Access Compliance Report

Public Rights-of-Way

(Curb Ramps)

Intersection ID: 24469	Main Street: MIROW_PL	Cross Street: SAINTFIELD_PL	Location: SE
ADA ID: E718A55D078F	Ramp Type: Perp	Initial Pass/Fail: Fail	Overall Compliance: No
Codes/Mitigation Info/Possible Solution			Severity Score: 25
			Field Measurements/Component Compliance

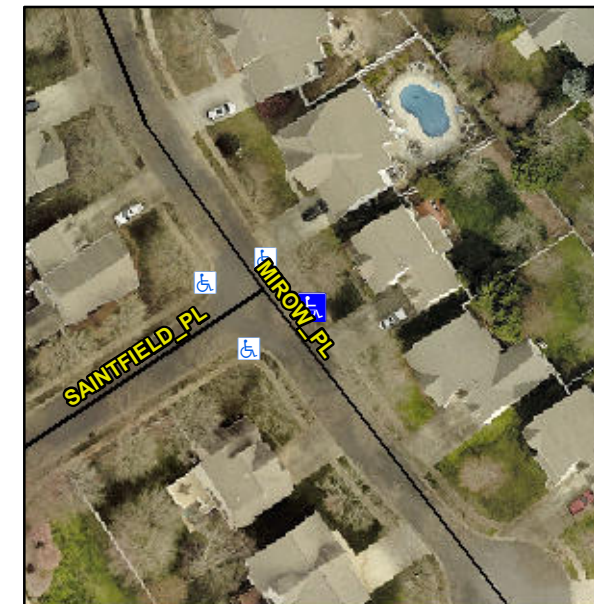
Not Found, R304.2.2, R304.5.3

Compliance	Description	Data	Compliance	Description	Data
N/A	Ramp Length (in)	46.0	No	Ramp Slope (%)	9.0
Yes	Ramp Width (in)	48.0	No	Ramp XSlope (%)	6.2
N/A	Flare Type LT	N/A	N/A	Flare Type RT	N/A
N/A	Flare Slope LT (%)	N/A	N/A	Flare Slope RT (%)	N/A
N/A	Flare Traversable LT?	N/A	N/A	Flare Traversable RT?	N/A
N/A	Landing Length (in)	N/A	N/A	DWS Provided?	N/A
N/A	Landing Width (in)	N/A	N/A	DWS Contrast?	N/A
N/A	Landing Slope (%)	N/A	N/A	DWS Length (in)	N/A
N/A	Landing X Slope (%)	N/A	N/A	DWS Full Width?	N/A
N/A	Landing Curb? (Y/N)	N/A	N/A	DWS Offset (in)	N/A
N/A	Shared Landing?	N/A			
N/A	Gutter Ponding?	N/A	N/A	Gutter Slope (%)	N/A
N/A	Gutter Lip Ht (in)	N/A	N/A	Gutter X Slope (%)	N/A
N/A	Painted X Walk1?	No	N/A	Painted X Walk2?	N/A
	X Walk 1 Direction	To W		X Walk 2 Direction	N/A
N/A	X Walk 1 Width (in)	N/A	N/A	X Walk 2 Width (in)	N/A
	X Walk 1 Slope (%)	2.1		X Walk 2 Slope (%)	N/A
	X Walk 1 X Slope (%)	4.1		X Walk 2 X Slope (%)	N/A

Remove & Replace Entire Ramp.
